INDESIT company

NMTP1912FHA

F054148

51721F0 Exploded views

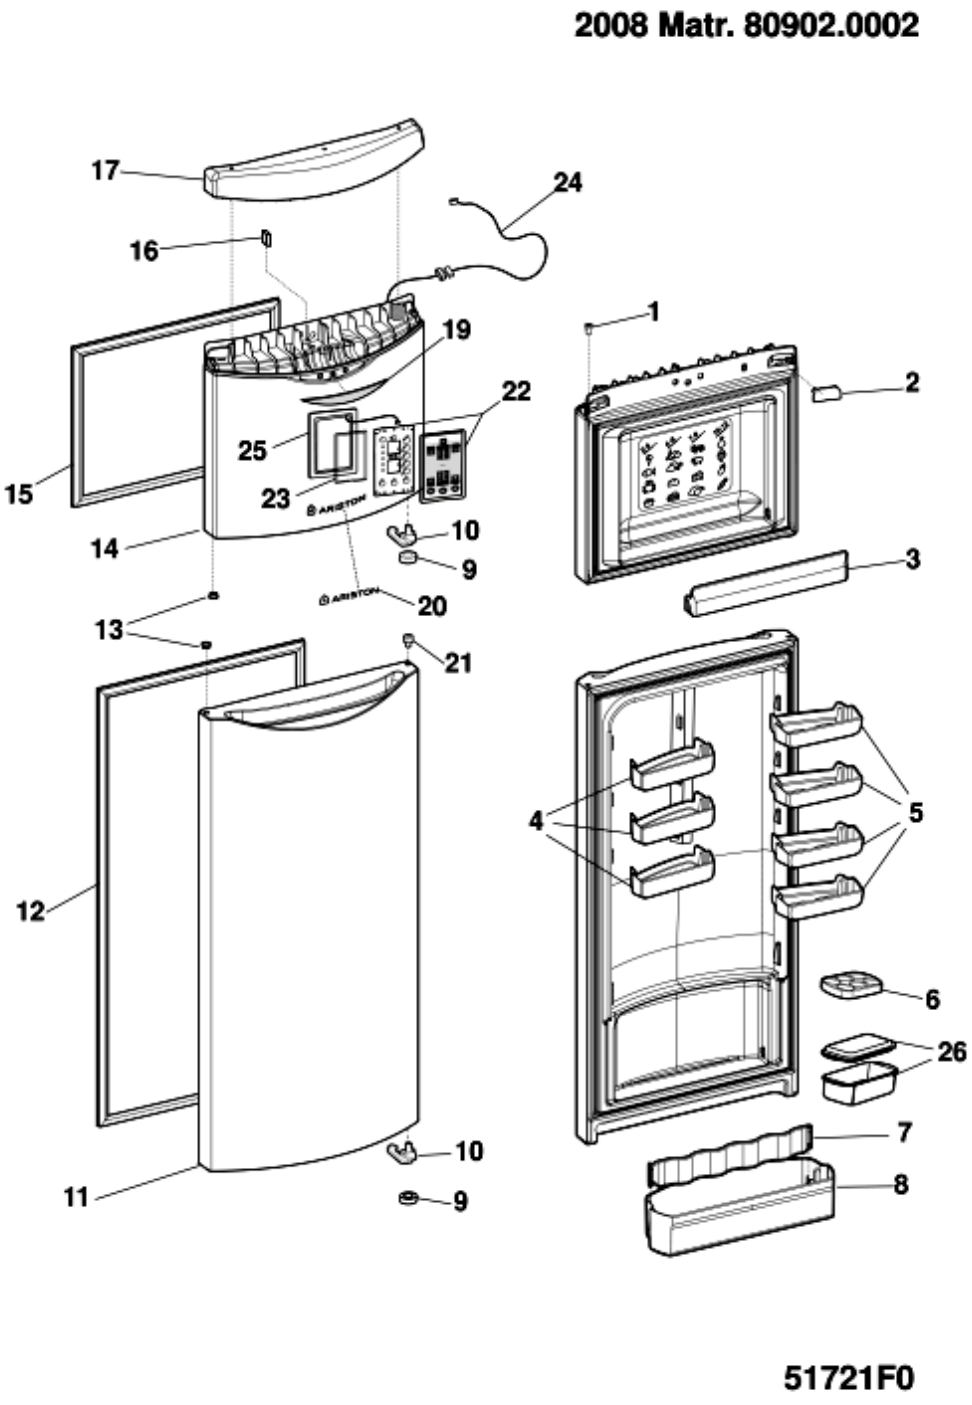
n2511j00: CHANGE DISPLAY FRAME

From S/N 91109... on products with display on door has been modified the aesthetical frame. Spare parts warehouse will continue to manage old and new frame, while doors will be managed only in post-modification version, so to substitute door on a pre-modification product it will be necessary to order new frame too (C00277308).

Doors involved are:

C00268866
C00268162
C00270151
C00271929
C00270644

RE0280T0 Exploded views

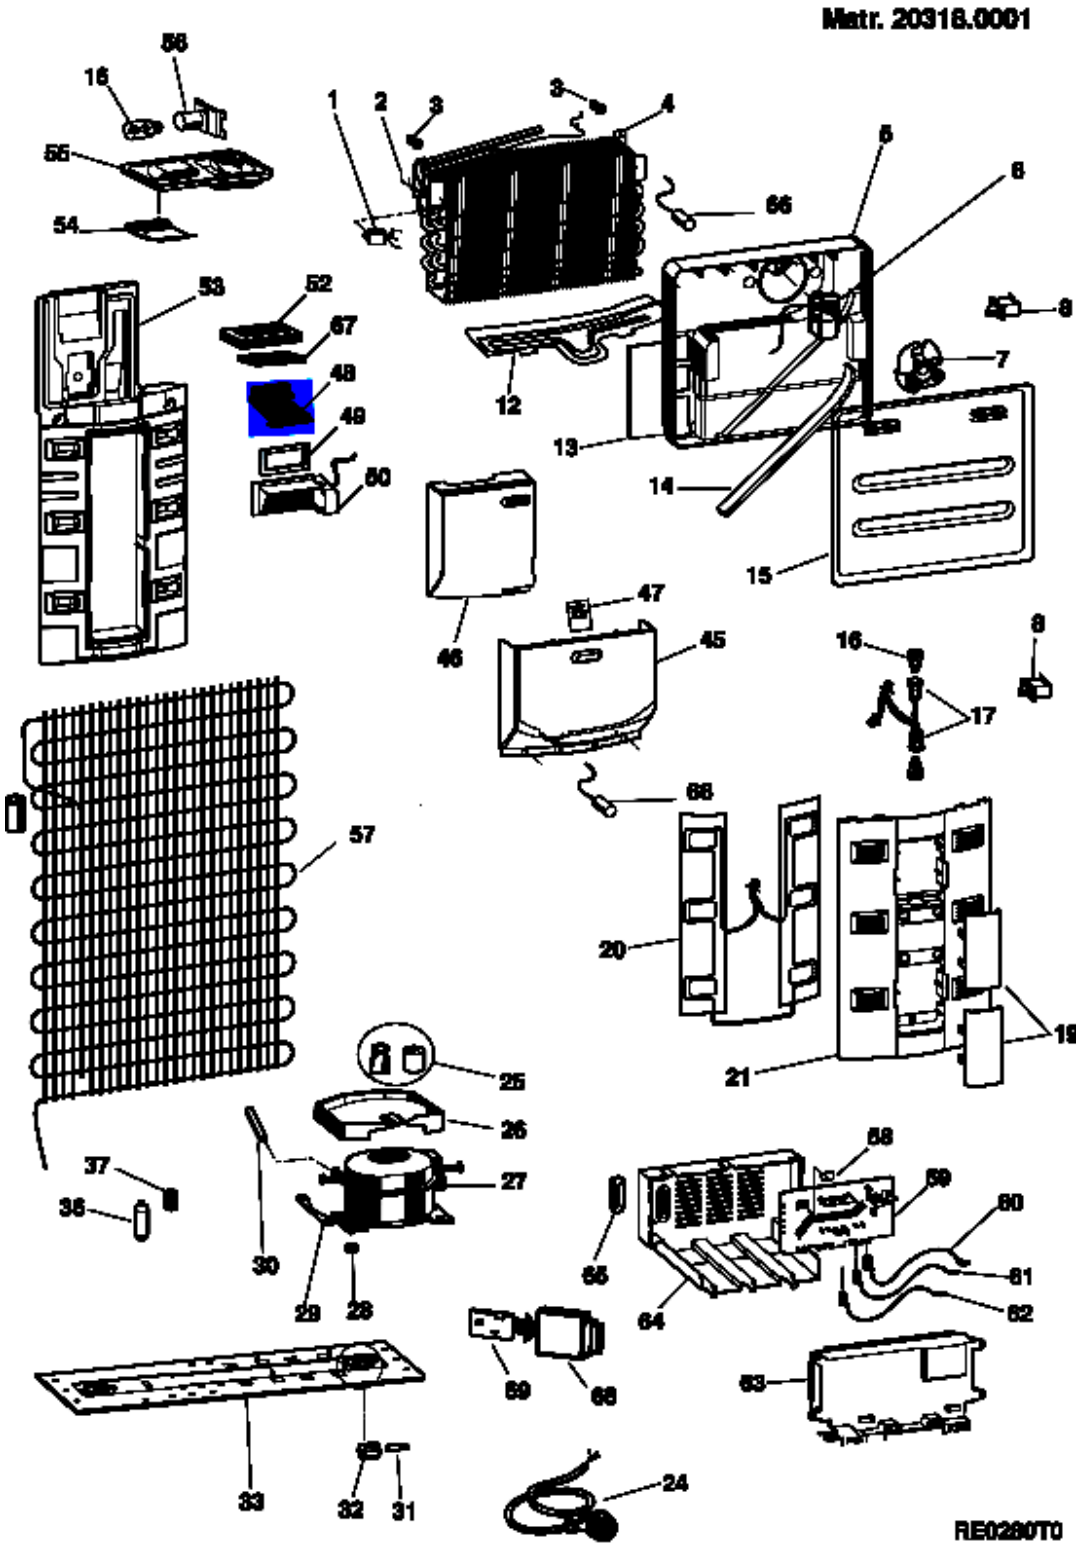
n3011b00: COMPRESSOR HTK12AA-2 (COPPER COIL TO COPPER+ALUMINIM COIL)
